ORIGINATION FORM

Proposed Revisions to a Standard Plans Index
(Please provide all information — Incomplete forms will be returned)

Index Number: 102-615
Sheet Number (s): 1 and 4 of 5
Index Title: Multilane Roadway, Intersection Work

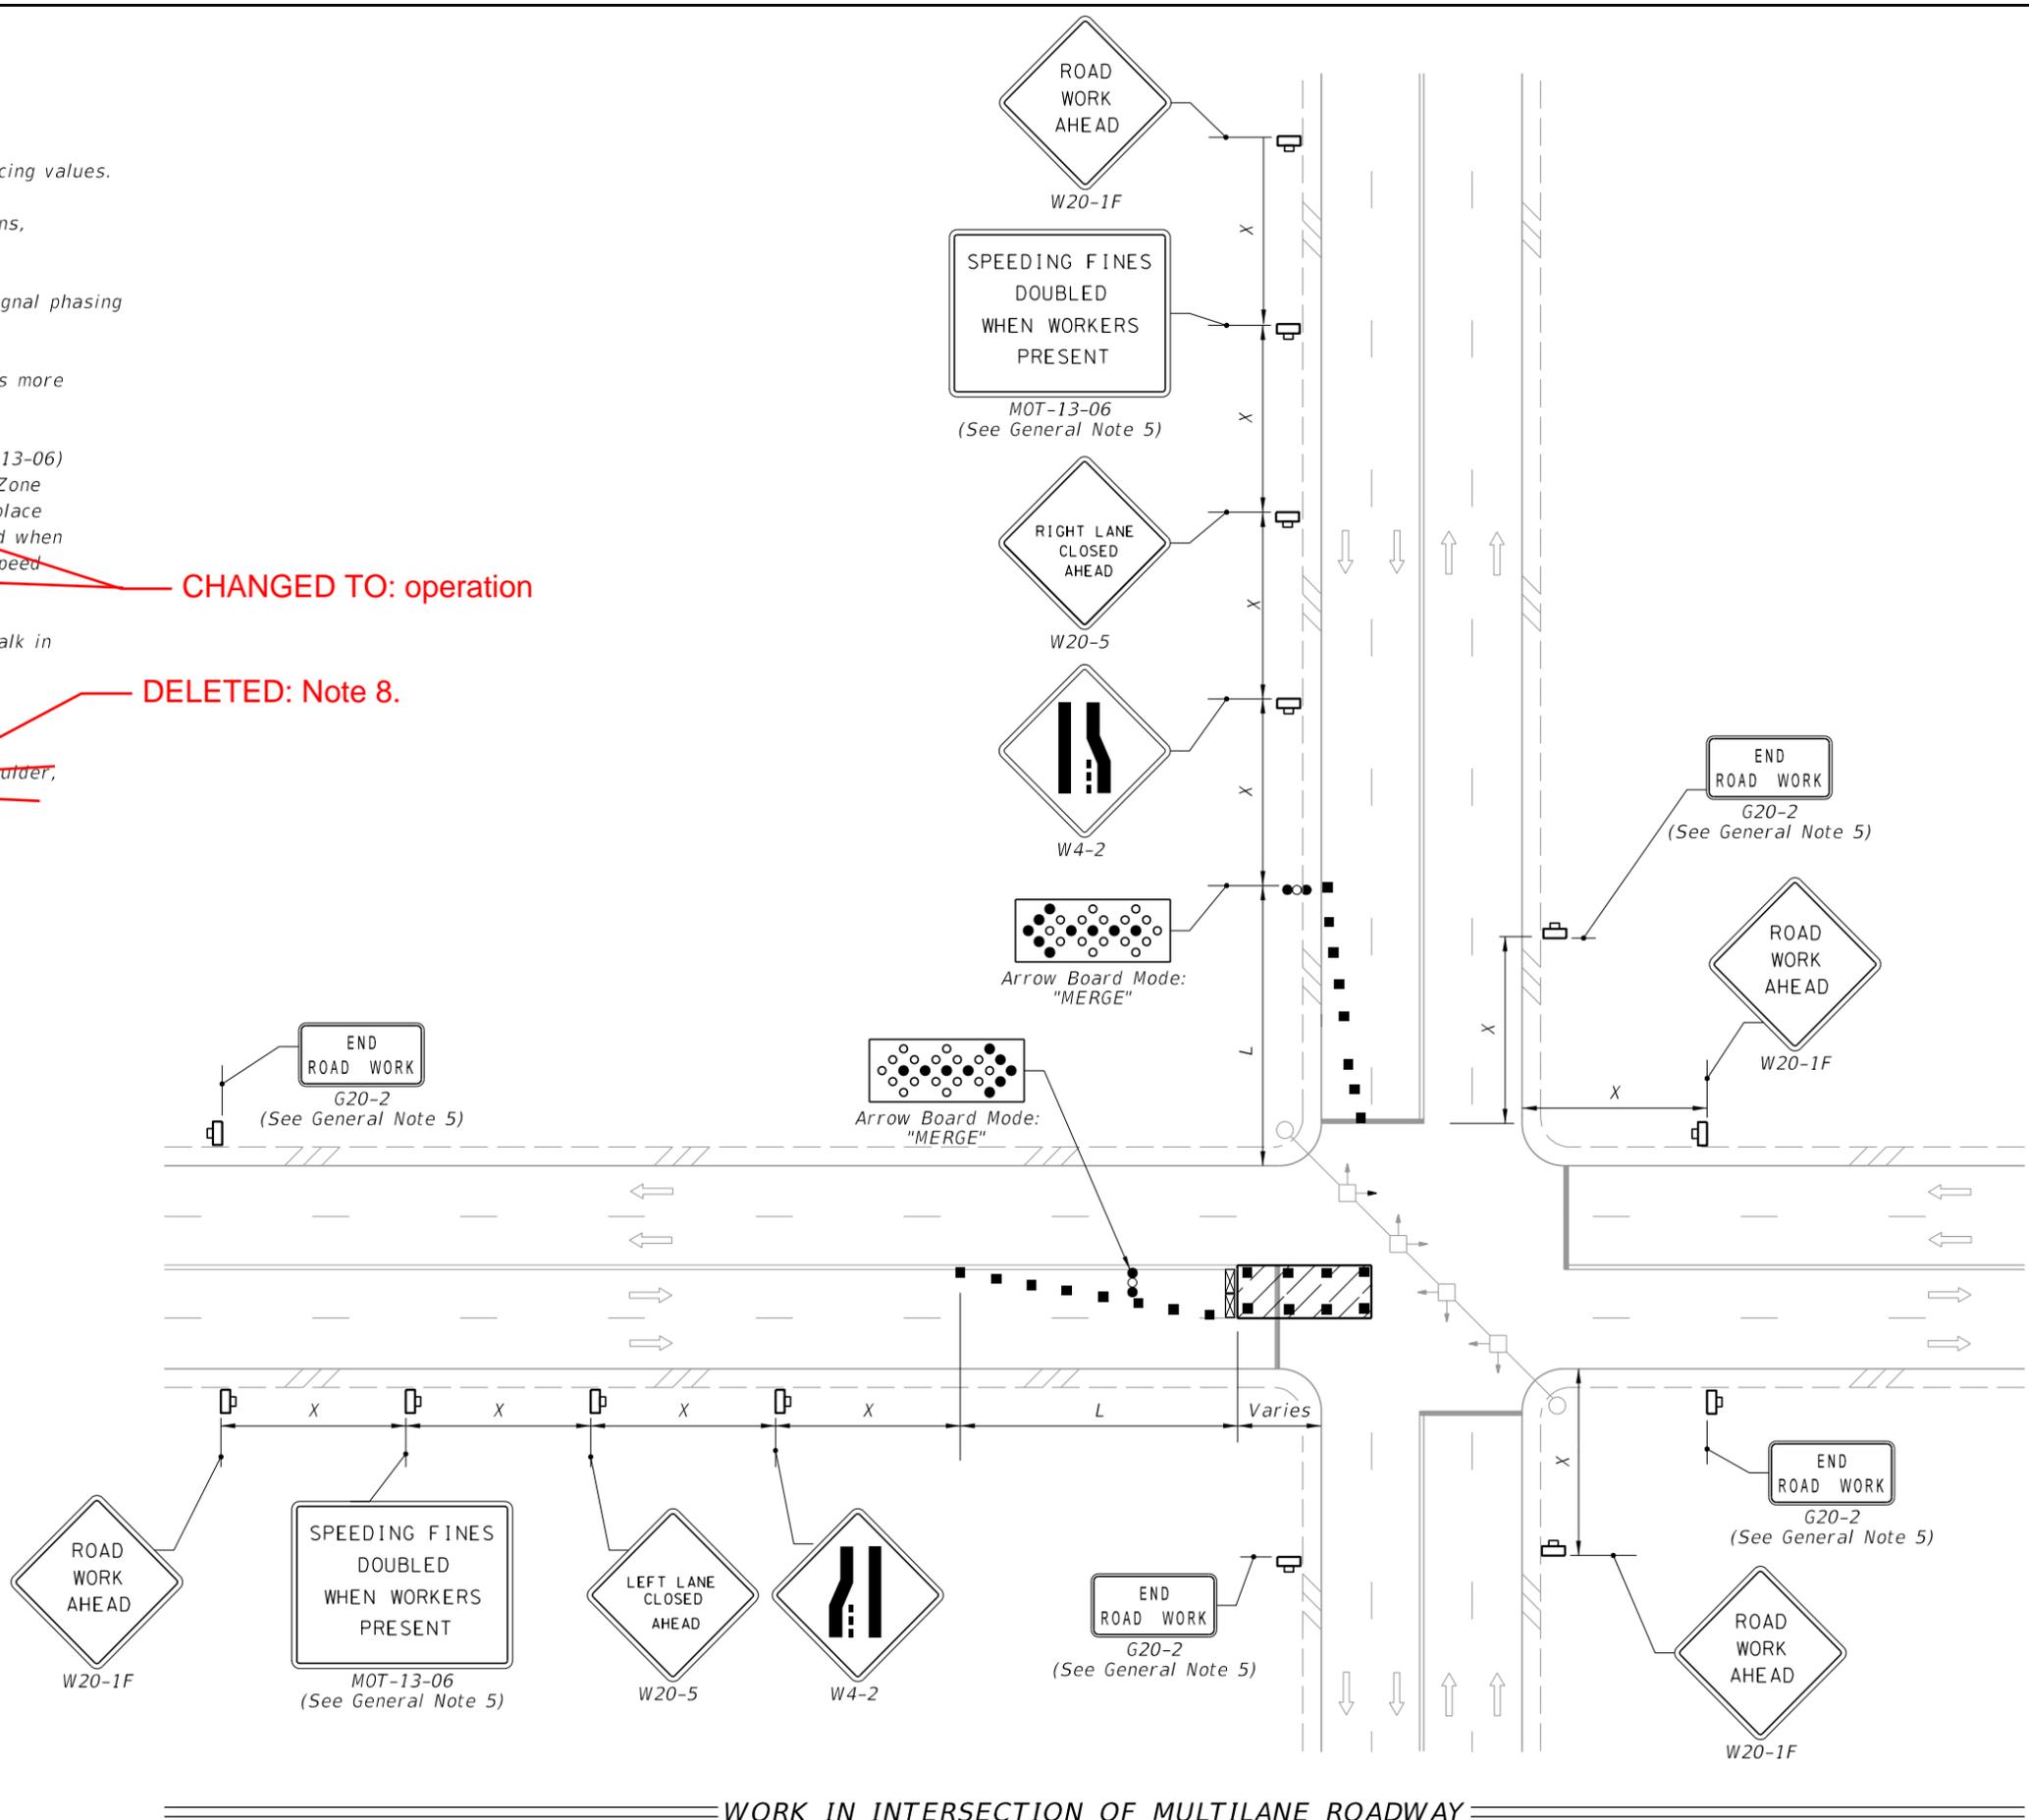
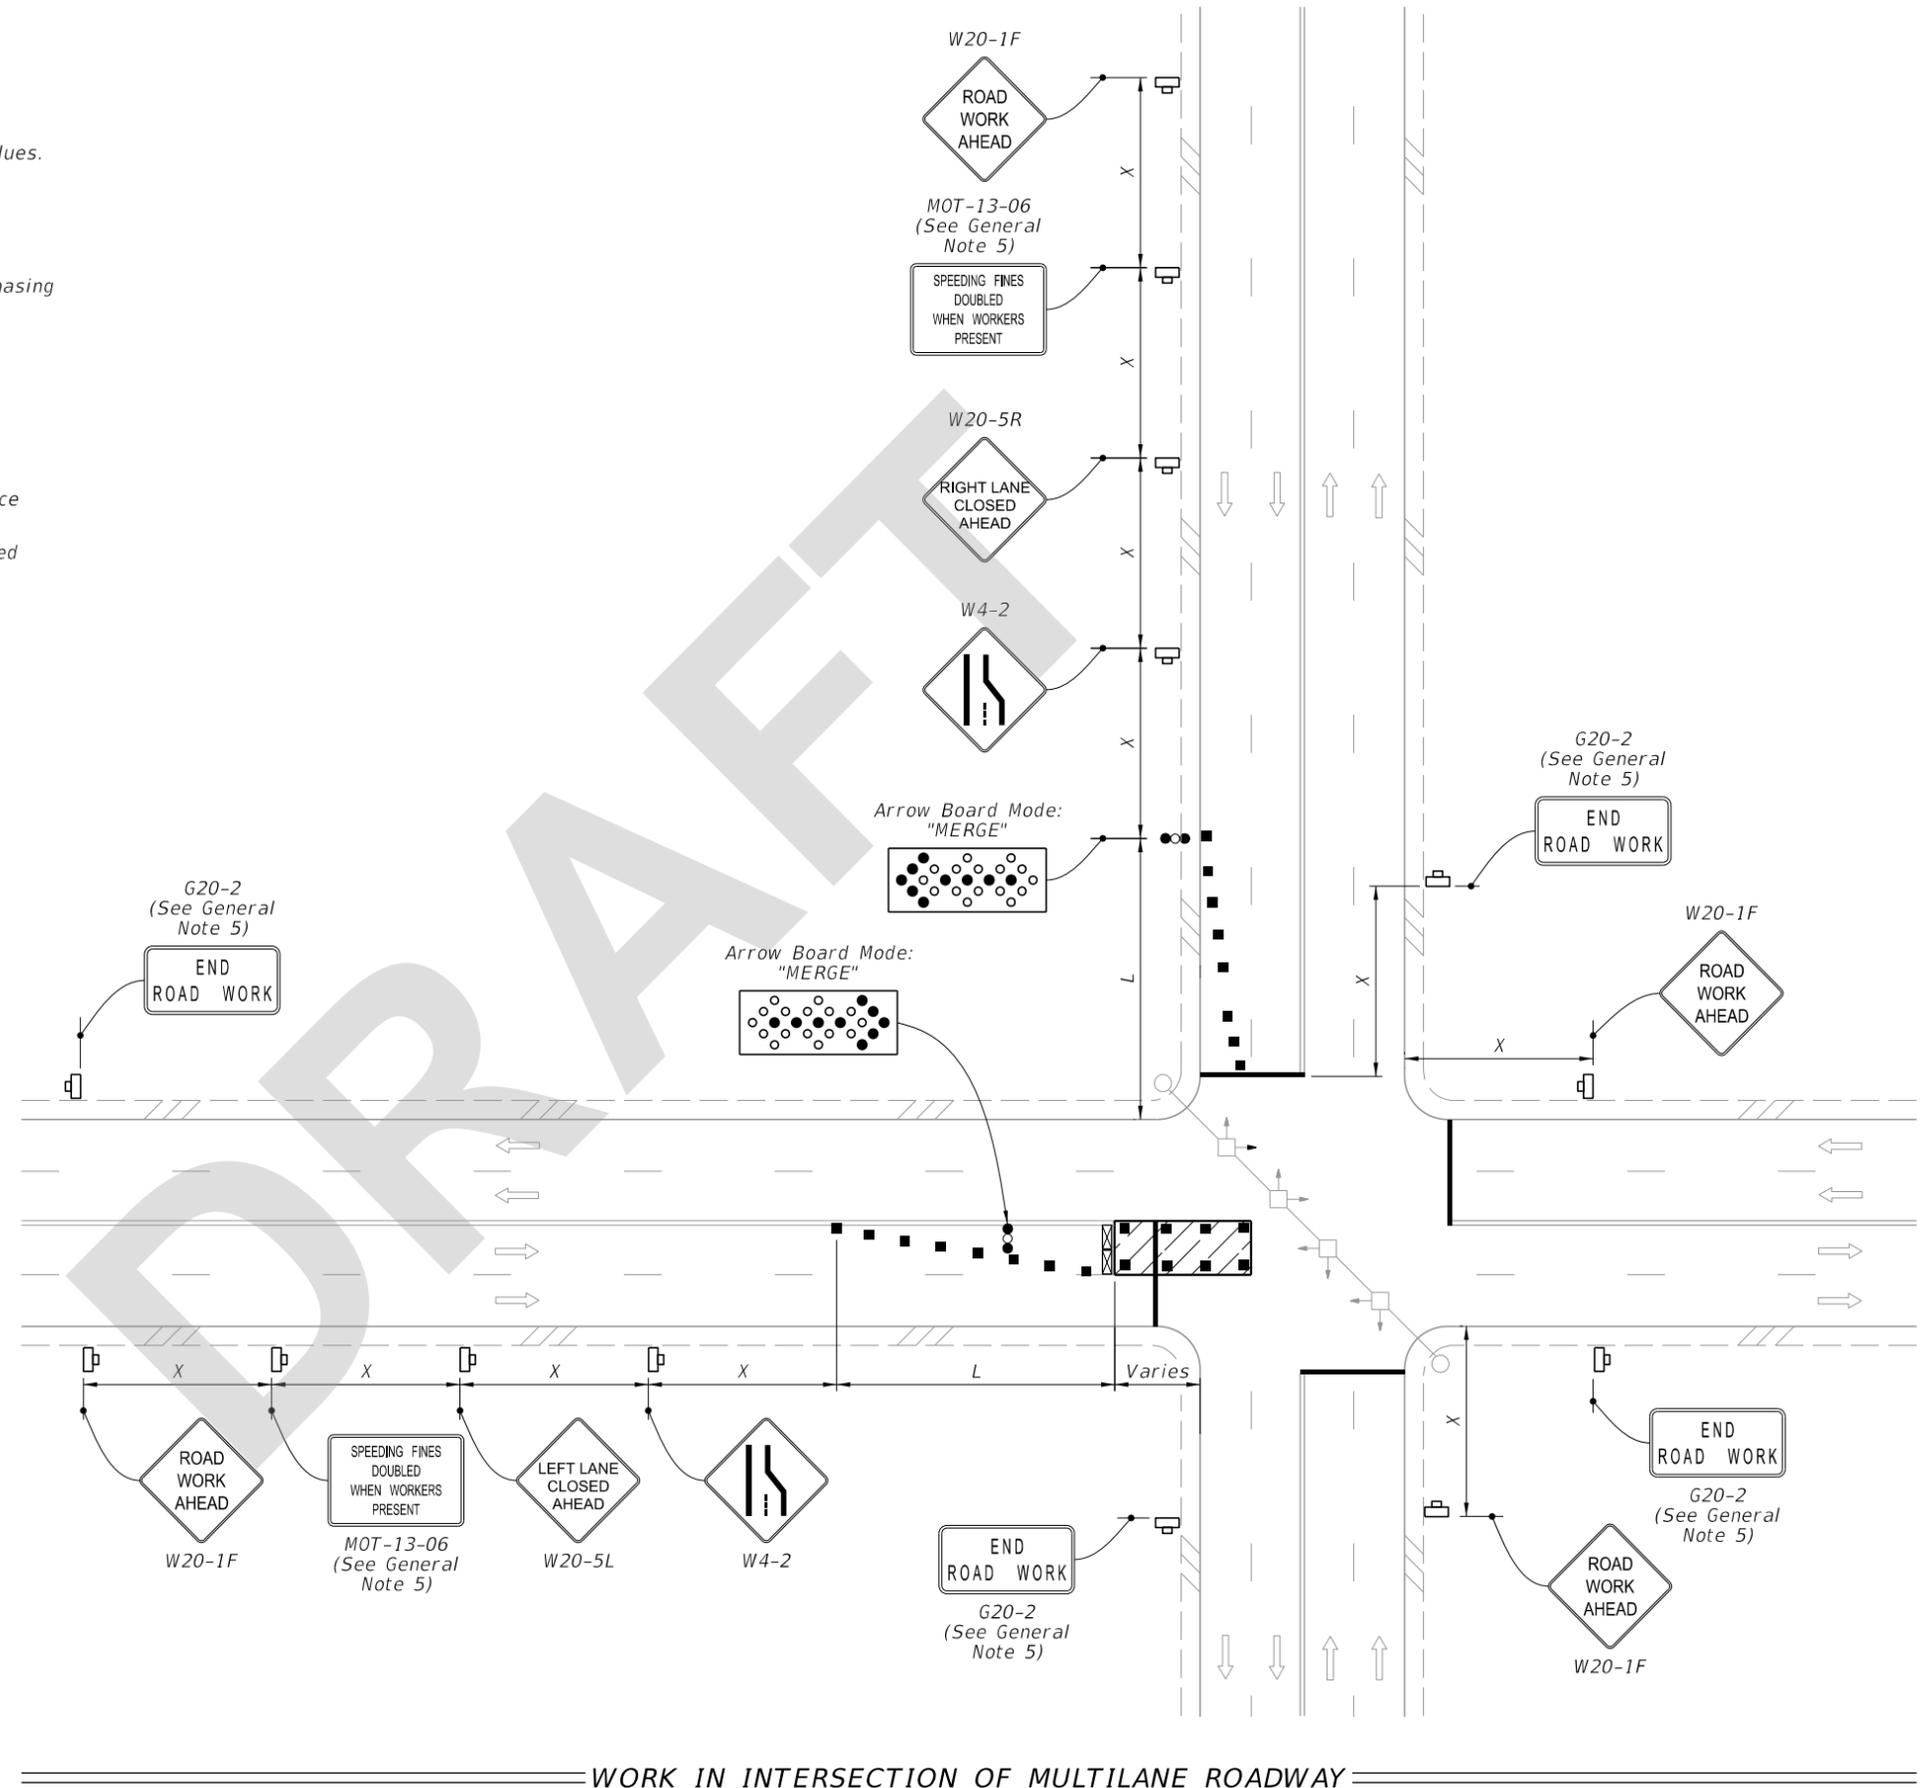
Sheet 1: Changed Note 5 - "work zone" to "work operation";
Deleted Note 8.
Added Arrow Board Mode: "Merge" to the detail.

CHANGED TO: operation

DELETED: Note 8.

The duration provisions of the index are intended to apply to the length time needed to perform the specific temporary traffic control work "operation" shown, which is independent of the duration of an overall construction project. The term "Work Zone" is being replaced with "Work Operation" to clarify the intent.

5. The "Speeding Fines Doubled When Workers Present" sign (MOT-13-06) and "End Road Work" Sign (G20-2), along with associated Work Zone Sign Distances, may be omitted when the work operation will be in place for 24 hours or less. Additionally, arrow boards may be omitted when the work operation will be in place for 60 minutes or less and the speed limit is 45 mph or less.
